**GE STOCKHOLDERS' ALLIANCE,
PATRICIA BIRNIE
PAGE 1 OF 1**

Re: OPPOSITION TO USE OF MIXED OXIDE FUEL FOR
COMMERCIAL REACTORS

Comment Documents
and Responses

FIGURE 1 (FROM DOE/MD-0002)

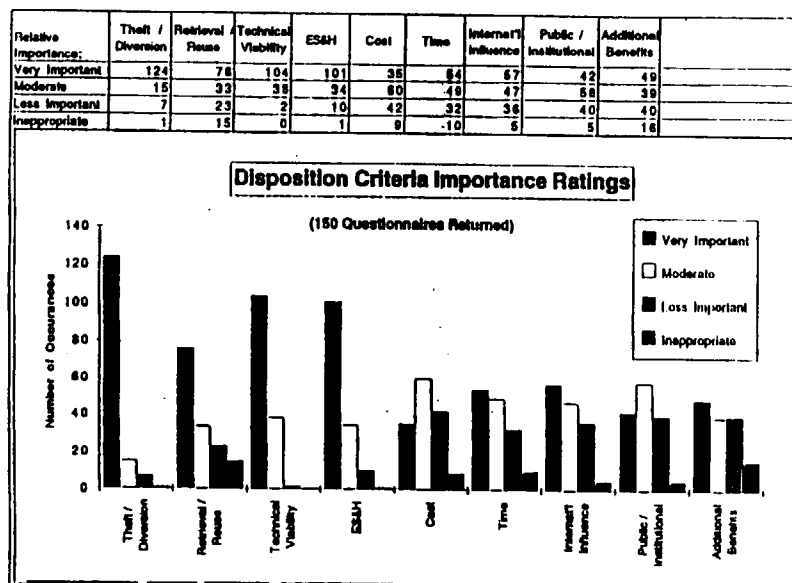
The screening report states that the spent fuel standard was generally accepted, except by "proponents of developmental technologies that could go beyond the spent fuel standard". This statement ignores the letter of December 13, 1994, from Senators Thurmond and Hollings and Representatives Spratt and Spence to Secretary O'Leary that questioned the adequacy of the spent fuel standard. It also continues to ignore the numerous comments in the public scoping meetings which indicated that measures beyond the spent fuel standard would be required to provide ultimate disposition of the plutonium, to ensure that the national security objectives of the plutonium disposition effort would be met, and to extract the maximum possible energy value from the plutonium. The DOE letter of April 14 states that, "all fission options which go beyond the spent fuel standard were deemed unreasonable." By precluding all options that can exceed the spent fuel standard prior to detailed, full evaluation in the PEIS, DOE has withheld important information from

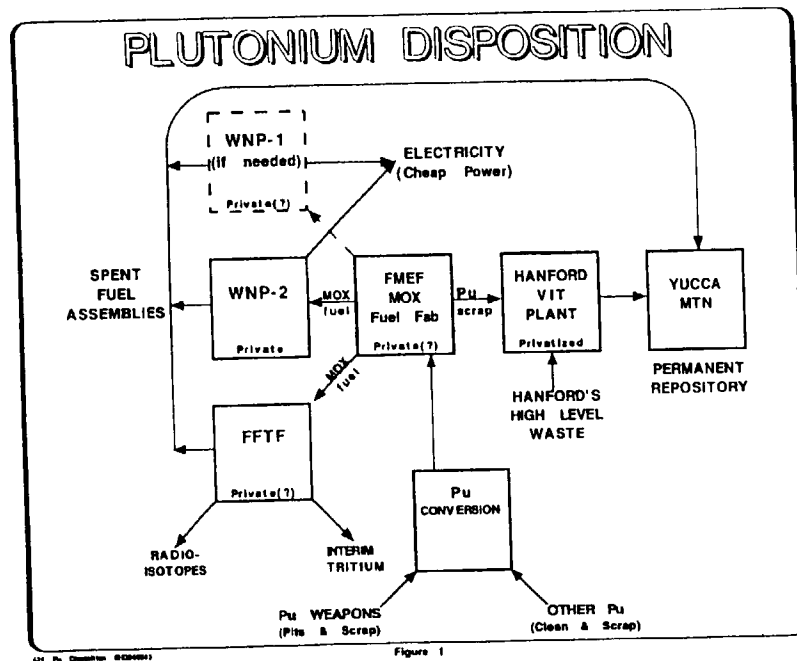
We urge you to formally and thoroughly examine the potential benefits of disposing of plutonium as depicted in the attached simplified schematic (Figure 1). We believe implementing this strategy will literally save DOE billions of dollars and shorten the time to initiate Pu disposition by at least 4 to 8 years. The schematic depicts a collocated plutonium disposition "system" involving compatible, already existing Hanford facilities plus new, already scheduled tank waste vitrification facilities. The plutonium conversion step indicated in the schematic could be at Hanford or elsewhere.
